Major Drainageway Infrastructure Alternatives - Walton Creek
Citywide Stormwater Master Plan
Steamboat Springs, Colorado

APPENDIX D –CORRESPONDENCE

Steamboat Springs Stormwater Master Plan

APPENDIX C – ALTERNATIVES ANALYSIS

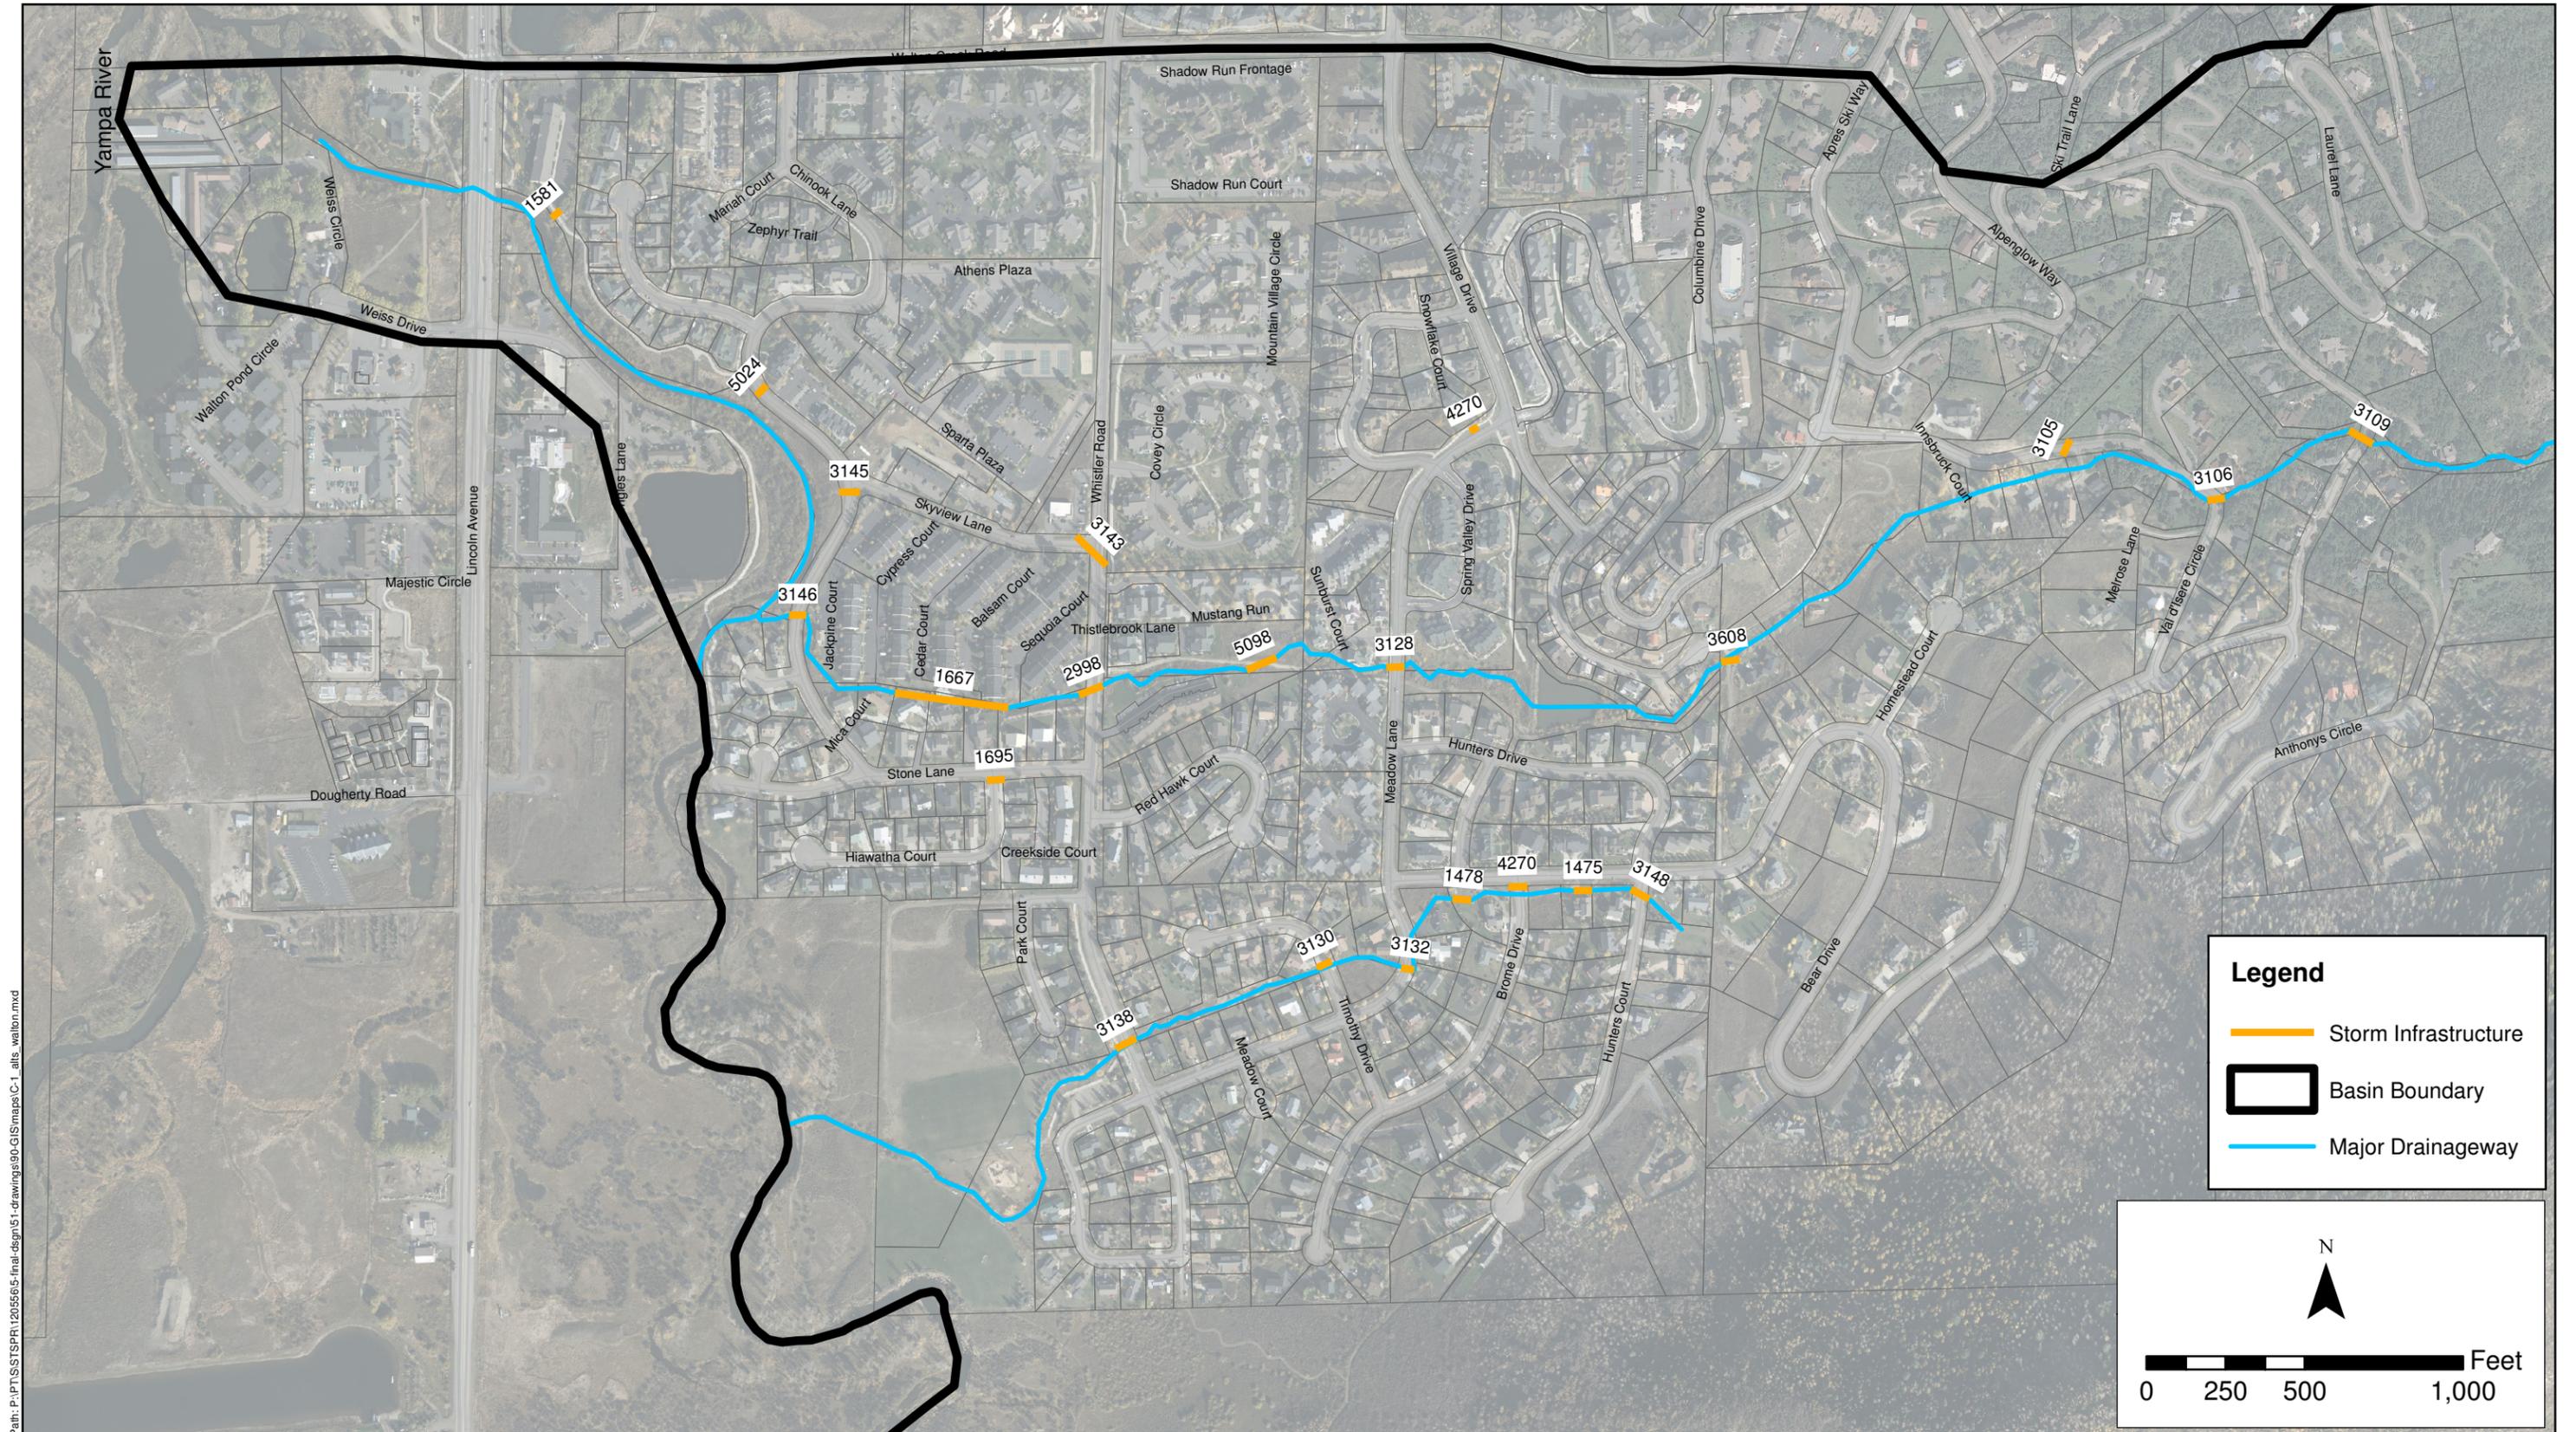
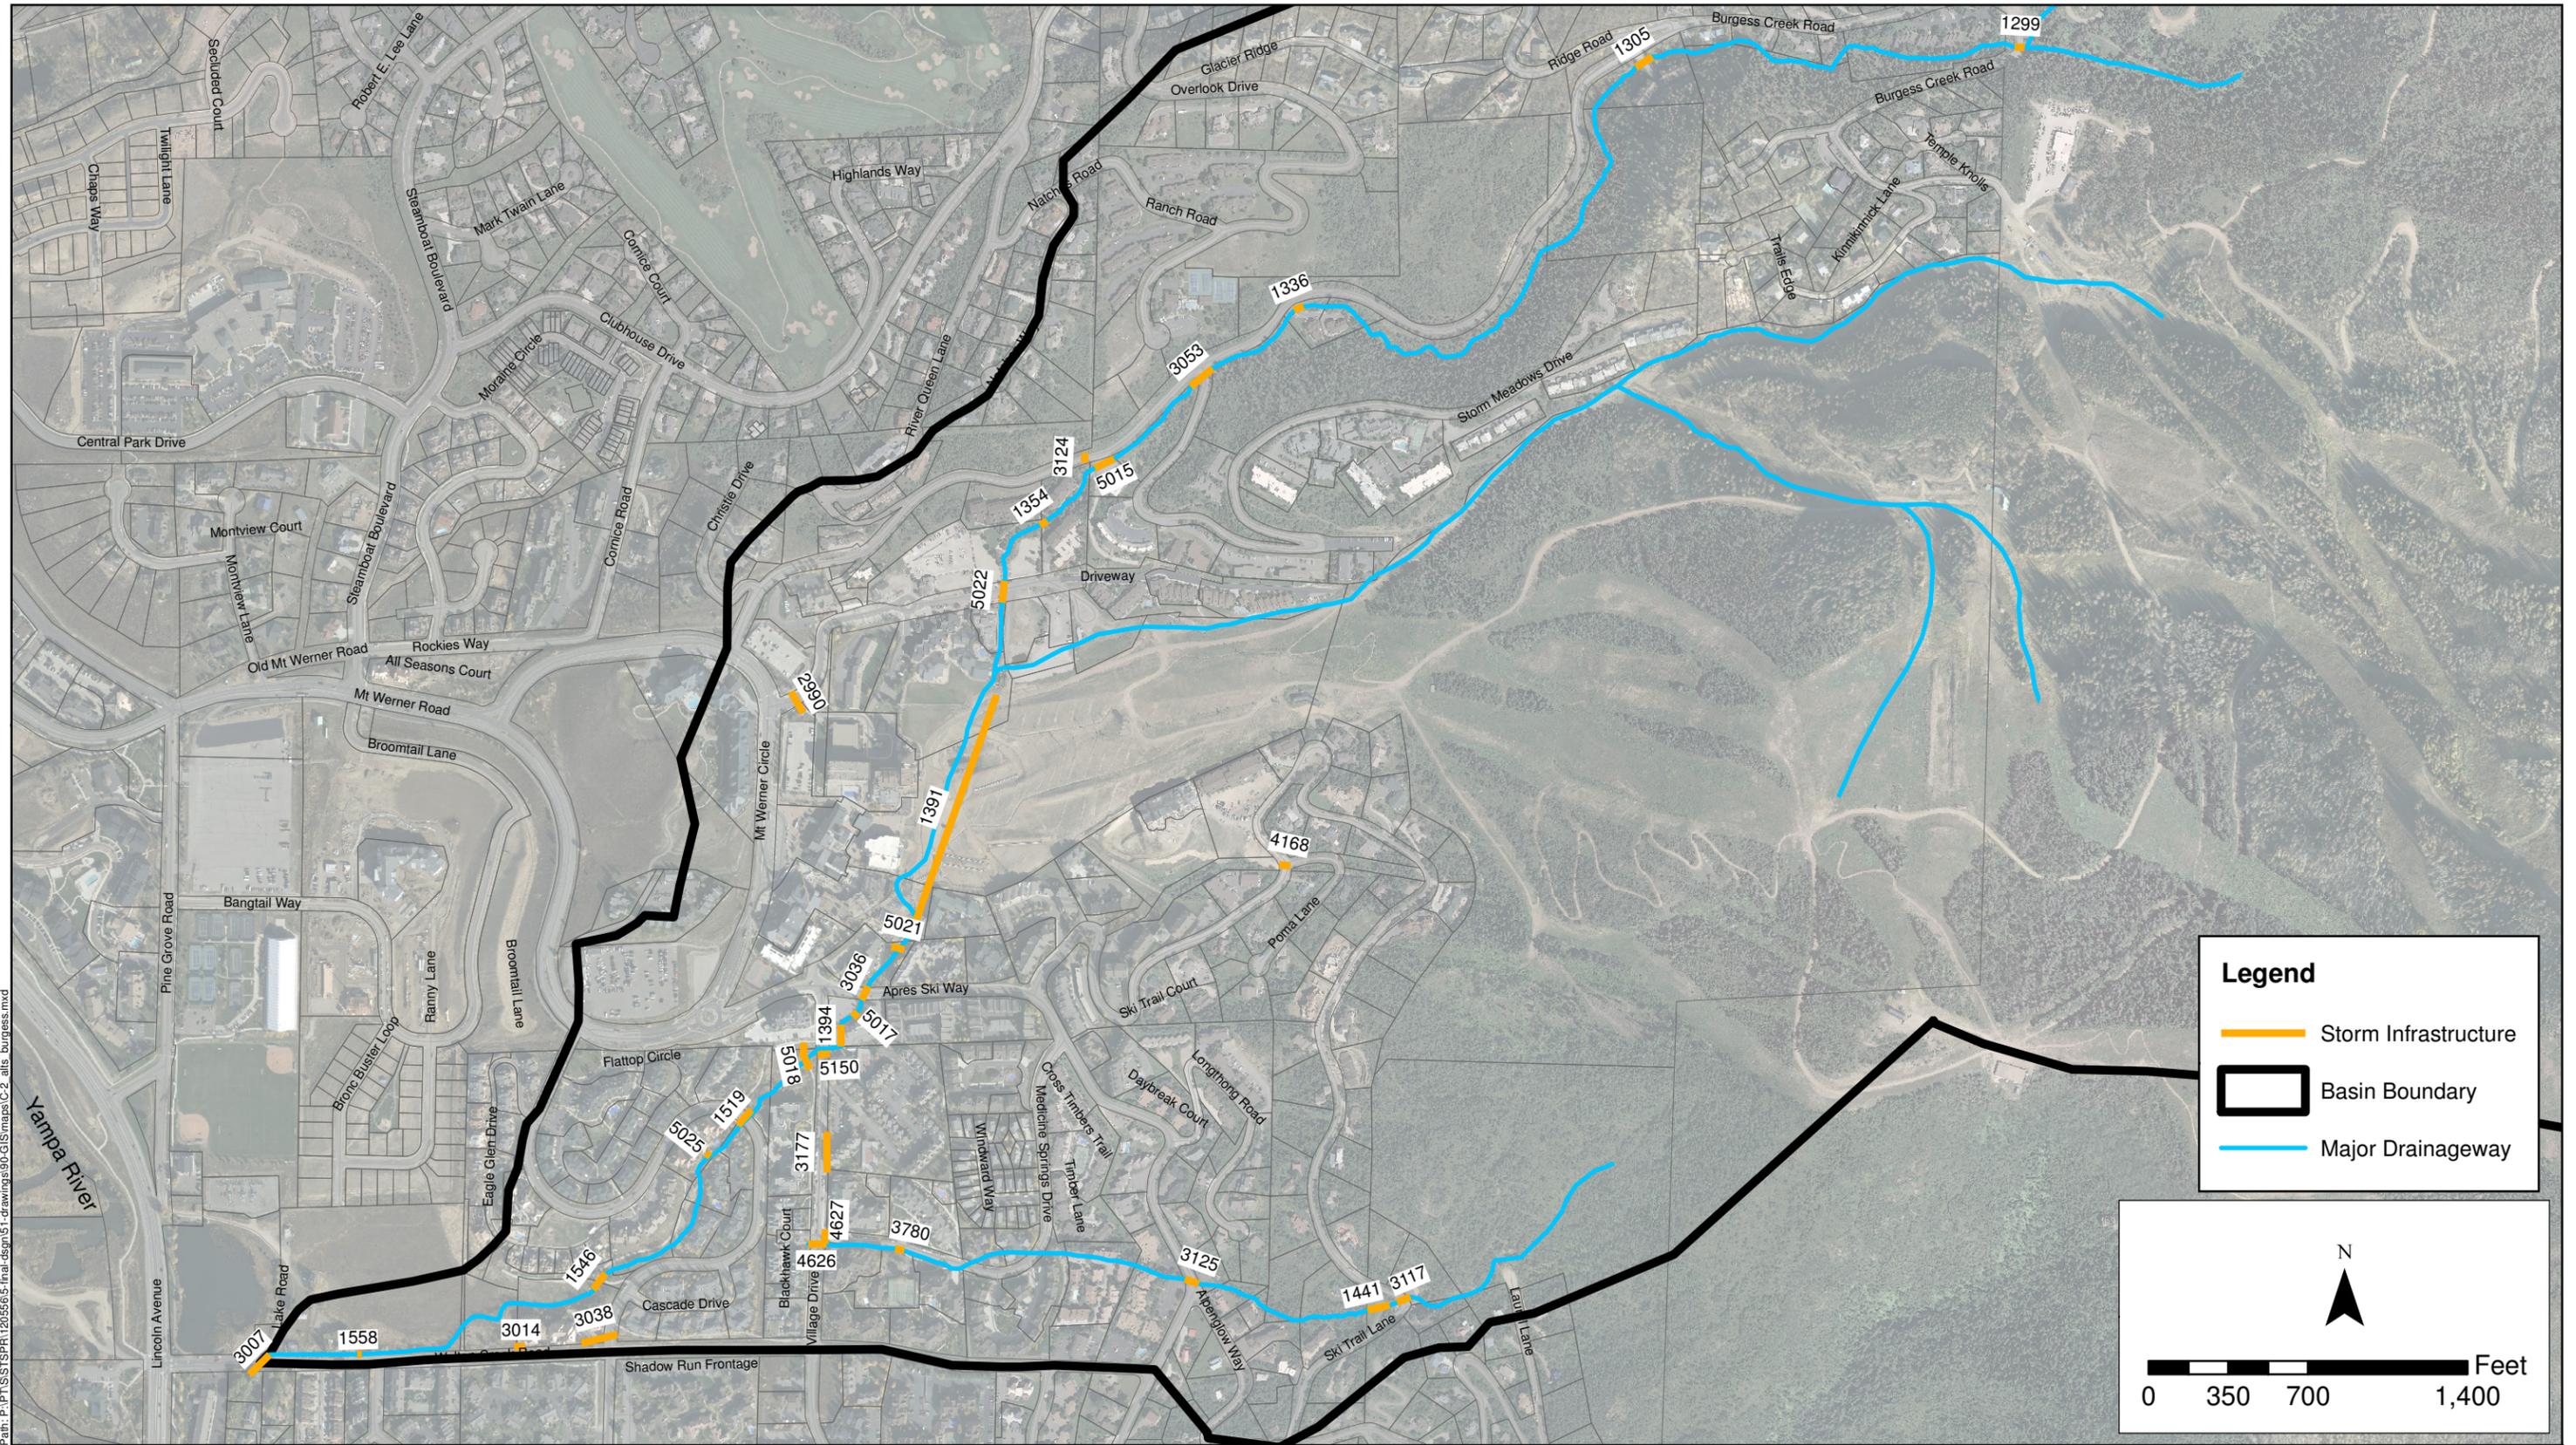
Ben Beall	Please add the culvert ID# as shown on the Problems and Needs Maps with the recommendations shown in the Alternatives Analysis in Appendix C.	The culvert ID# has been added to the spreadsheets in Appendix C for easier cross referencing.
Ben Beall	In 2.2.10, you describe EM/ORM as slightly larger than 2 acres. Is this a typo? Should it read "2 square miles?"	Yes, the EM/ORM basin is just over 2 square miles in size.
Ben Beall	You list in the Problems and Needs written section that the drainage at Skyview Lane should be addressed, yet there is no graphic representation of this on the Problems and Needs map. What needs to be done at this intersection? This location was specifically identified as a problem drainage location at the May 15th kickoff meeting. The required improvements and estimated cost should also be captured in Table C-1 when that is complete and the reference numbers are included. In Table C-1 you show that there are 3 36" existing CMP. There are only 2 that cross under Whistler, plus a third smaller culvert.	The east roadside swale/ditch for Whistler Road does not have sufficient capacity to convey flows, and backs up onto the street. Twin 36-inch CMPs carry flow beneath Whistler Road to the north roadside swale/ditch for Skyview Lane. The 3rd, smaller culvert is non-functional according to City staff. Redevelopment of the northwest corner of this intersection includes a proposal to convey part of the flows to the south roadside swale/ditch of Skyview Lane.

Ben Beall	It does not appear that the recommendations on the Problems and Needs Map match the recommendations on the Alternatives Analysis. For example, for Burgess Creek at Stonecreek Court on the P/N map, you show clearing the culvert to restore capacity (#25 and #26) and in the Alternatives Analysis you show replacing with a 66" RCP (#1336). That means that we are assigning a replacement cost to the overall numbers when you are recommending immediate maintenance only elsewhere. It appears that the alternative analysis sizes ALL culverts to convey the 100-year flow. The City Drainage Criteria does not require this of all culverts. It requires 100yr capacity for all collector and arterial roads and 5yr capacity for all others. We discussed this at length in progress meetings. Why are you including costs to replace culverts that meet current City Drainage criteria?	We recommend clearing culverts to restore capacity in every case where we observed clogged culverts in the field. Clearing clogged culverts optimizes the existing stormwater conveyance system. The existing culvert at Stonecreek Court at Burgess Creek needs to be replaced to convey the 100-year storm event. We used the 100-year storm event because the 100-year event is an engineering standard, and to be conservative for stormwater funding purposes. Because this is a conceptual-level report for stormwater funding purposes, we agreed to use the 100-year storm event for modeling purposes. When more detailed outfall systems planning studies are performed on a basin-by-basin basis, more scrutiny can be applied to individual issues, problems, and needs.
